Department of Energy
Office of Legacy Management

Subject: Naturita and Slick Rock, Colorado, Sites

Responses to Bill VonTill Questions for May 3, 2005 Visit

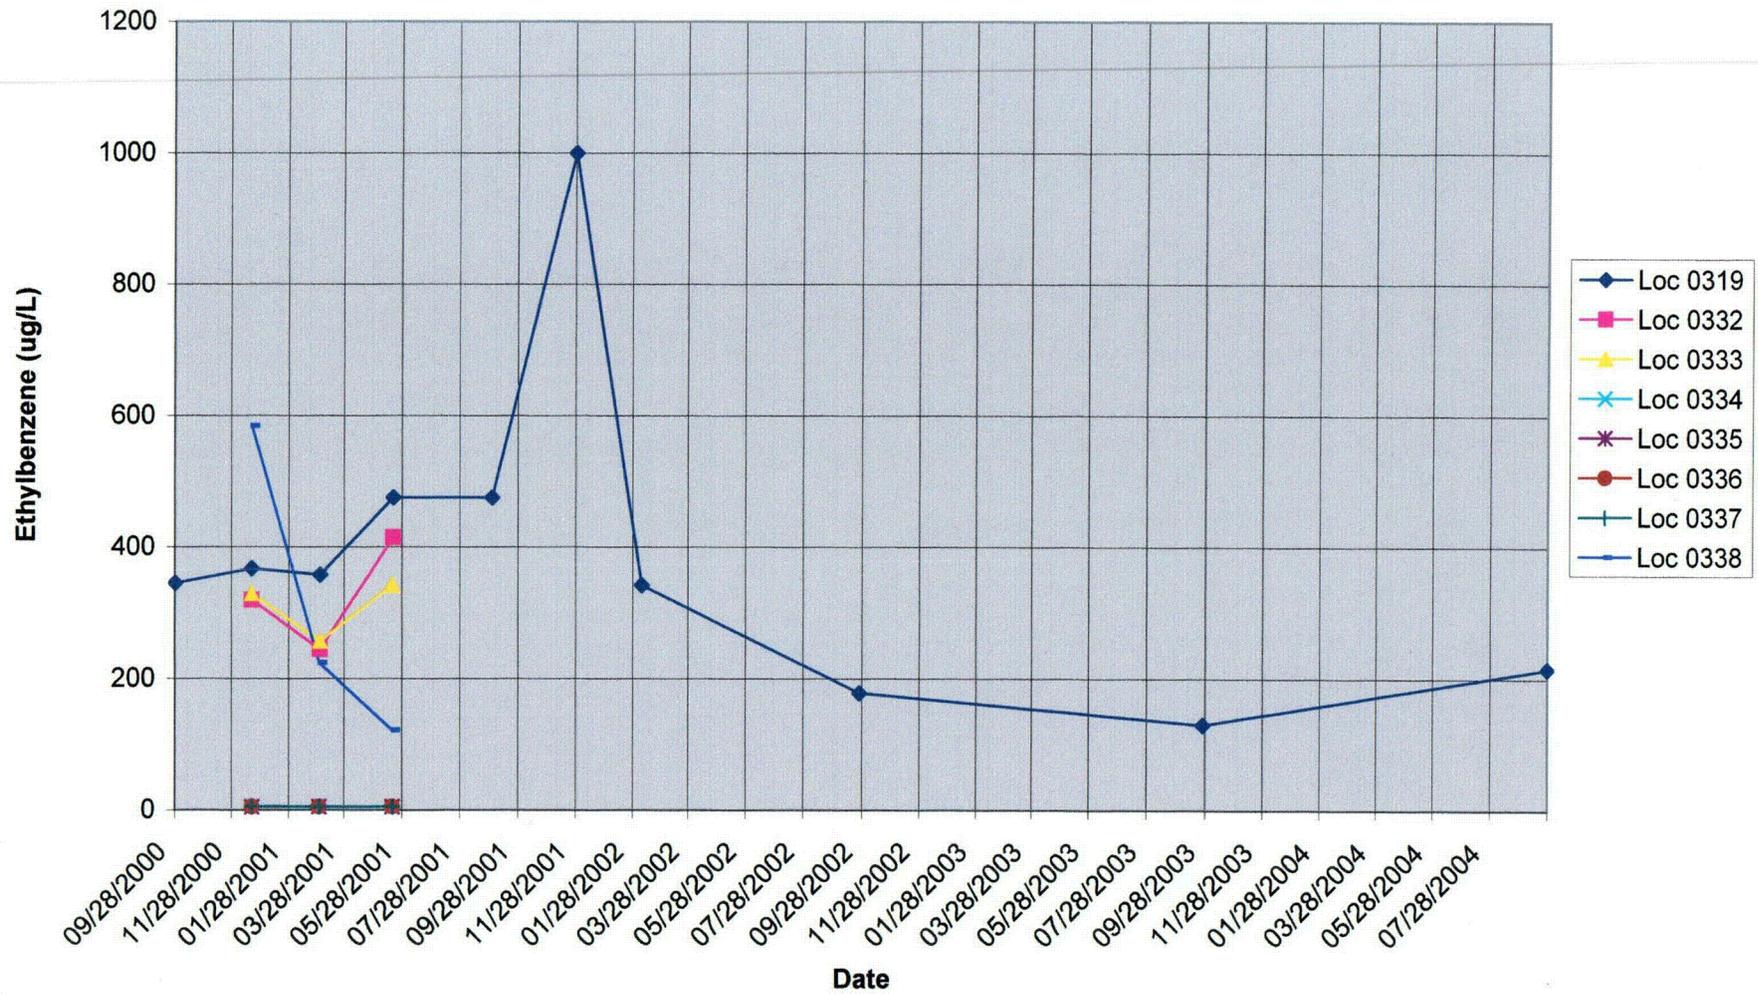
1. Q. Is uranium increasing at the seep?
A. A time/concentration graph for the seep at Naturita, location 0538, is enclosed. It shows an increase from sampling conducted in 1994 – 1995 to sampling started in 2001. From 2001 forward, it shows a fairly steady concentration. The reason for the low value in late 2001 is unknown.

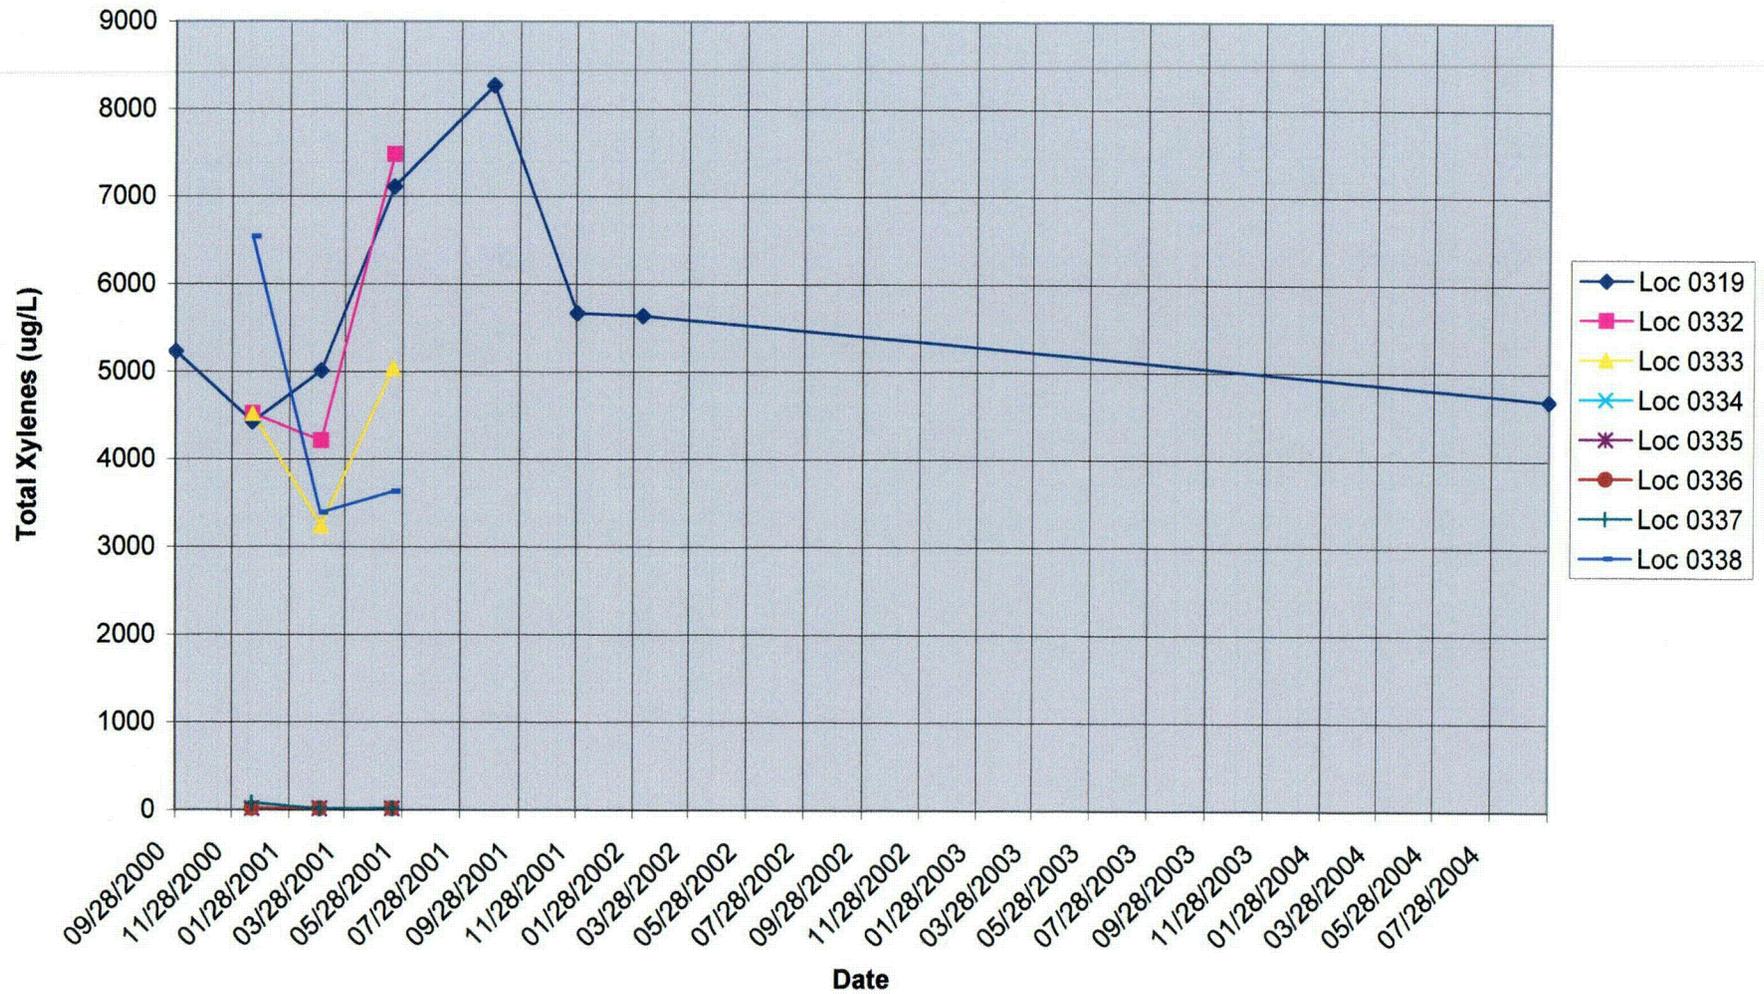
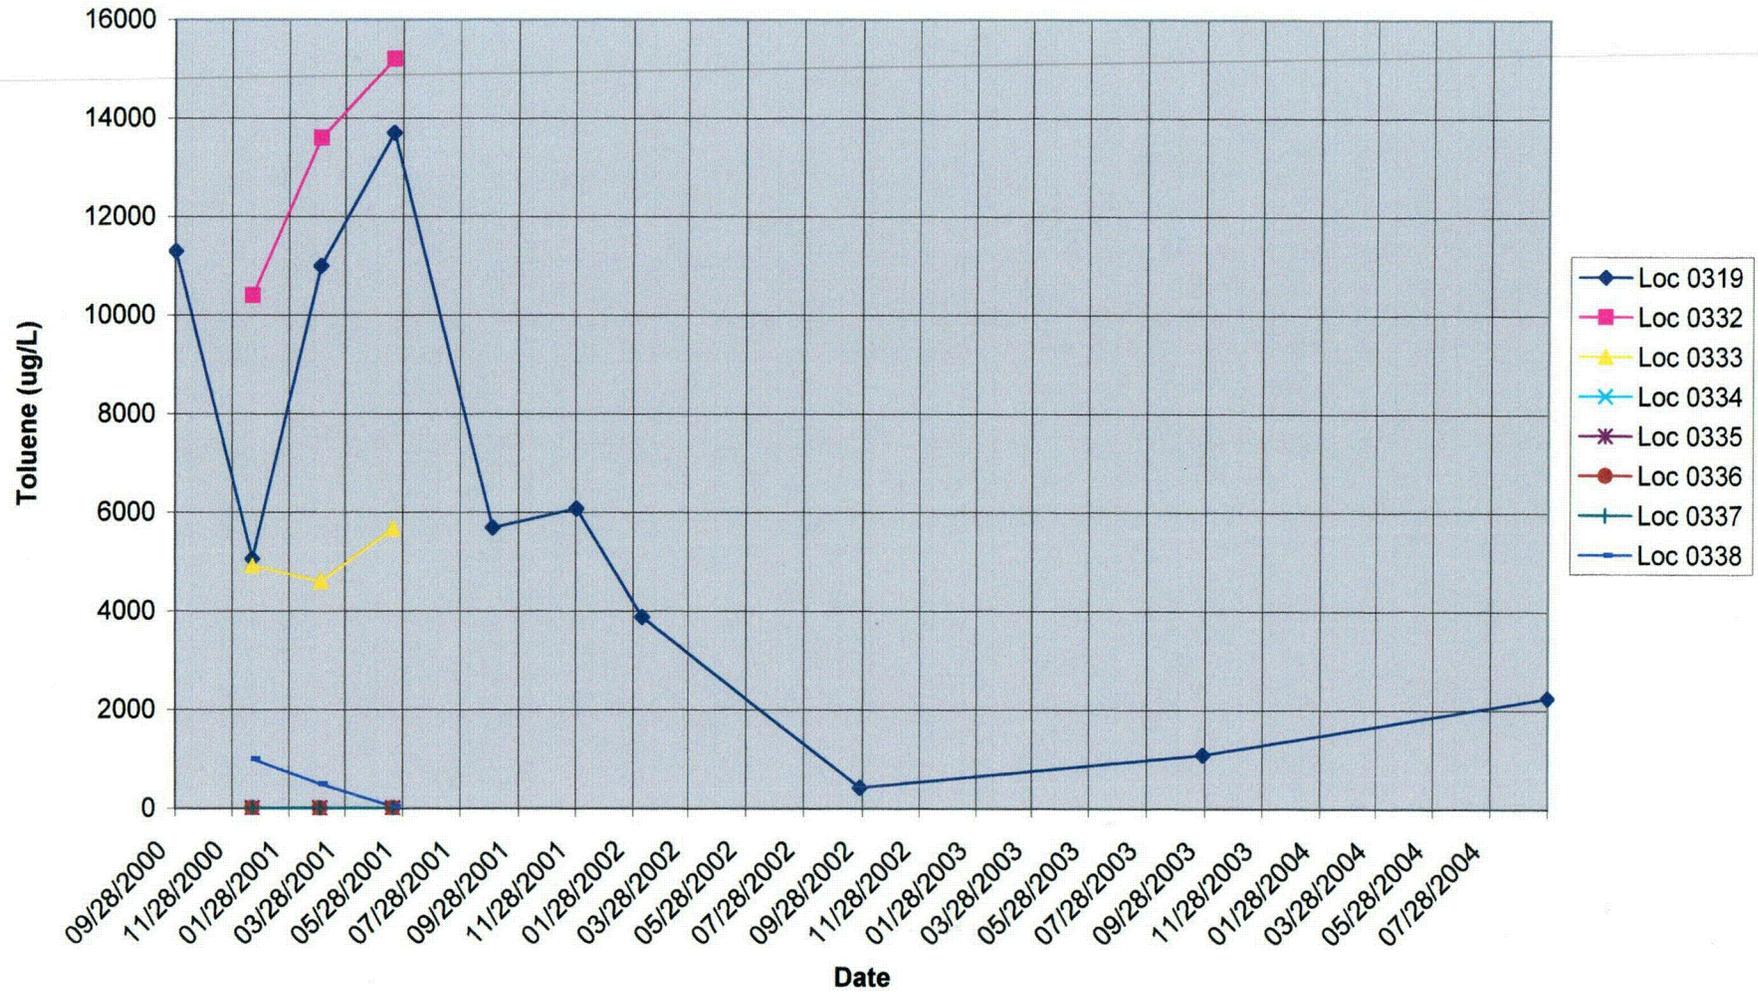
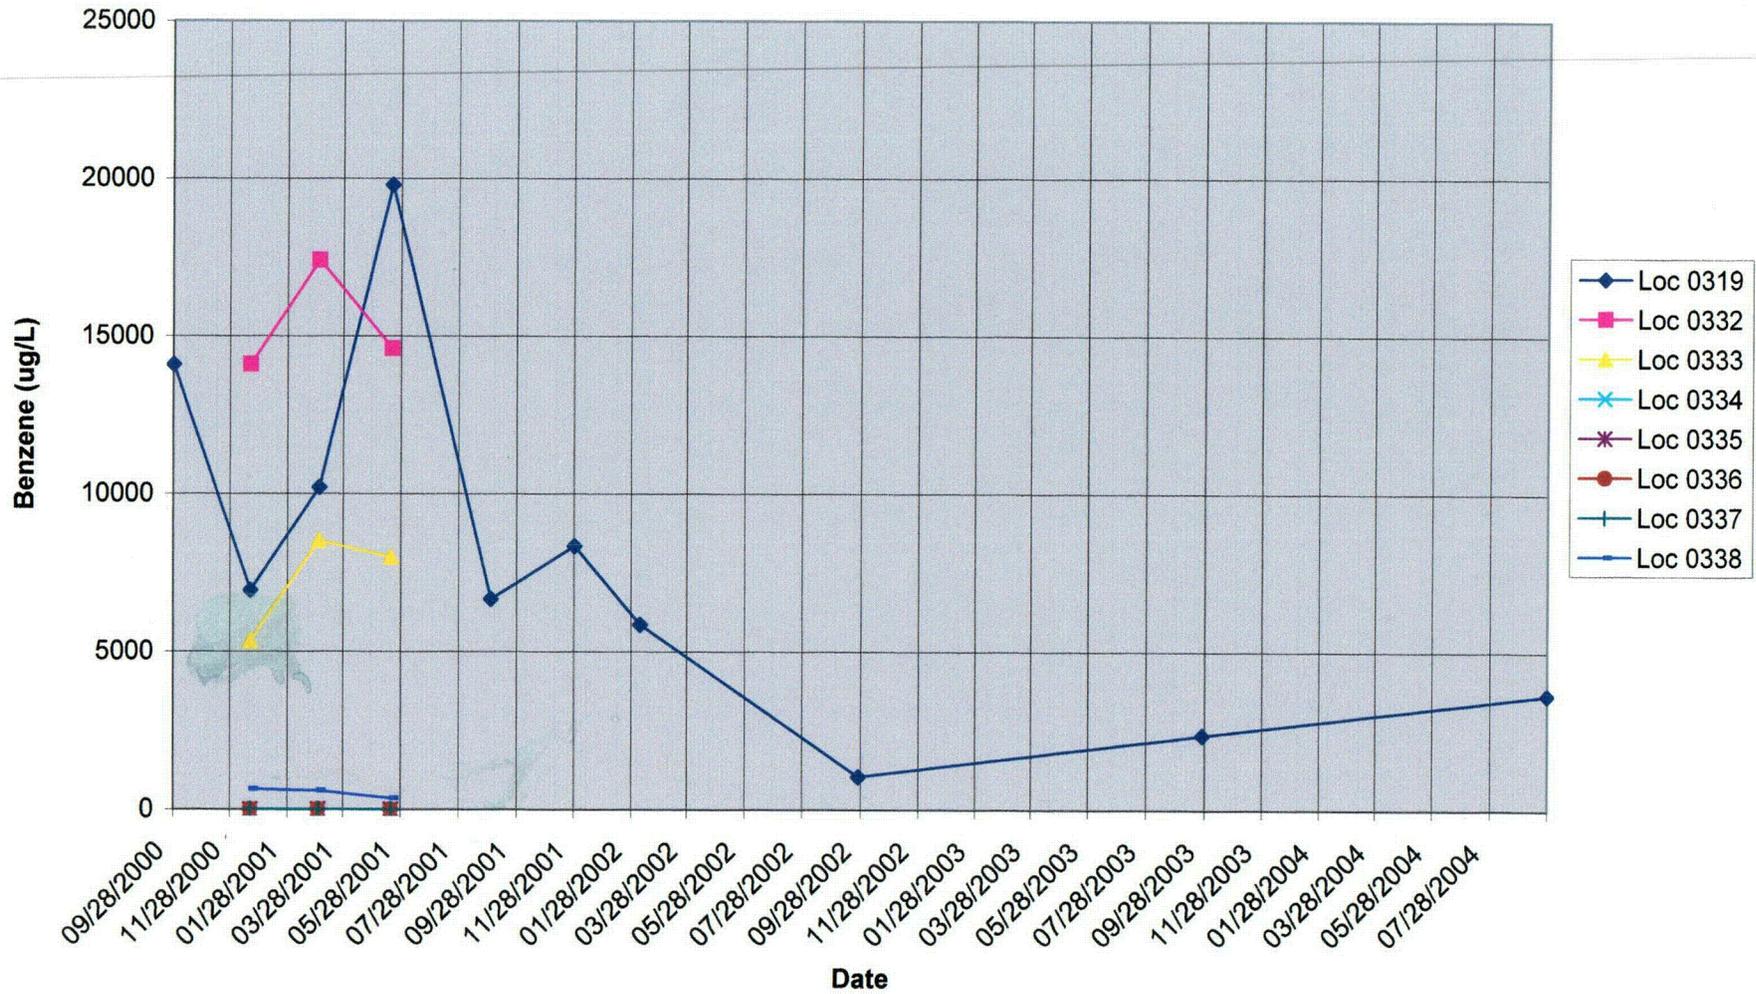
3. Q. Provide more information about the hydrocarbon spike found in well 0319. Is free produce found in the well? Was there more characterization? Was the plume mapped? Was free produce found in the well?

A. Considerable effort was expended in 2000 and 2001 to study the hydrocarbons found at the site. A number of well points were installed and sampled and were decommissioned in 2001. Time/concentration plots of data collected from these shallow wells are provided for BTEX, see enclosed graphs. Only well 0319 remains and is being sampled. A brief description of the Characterization Plan and Results is enclosed. According to the sampling team, free produce did not appear on the surface of the water in well 0319. It was concluded that the plume
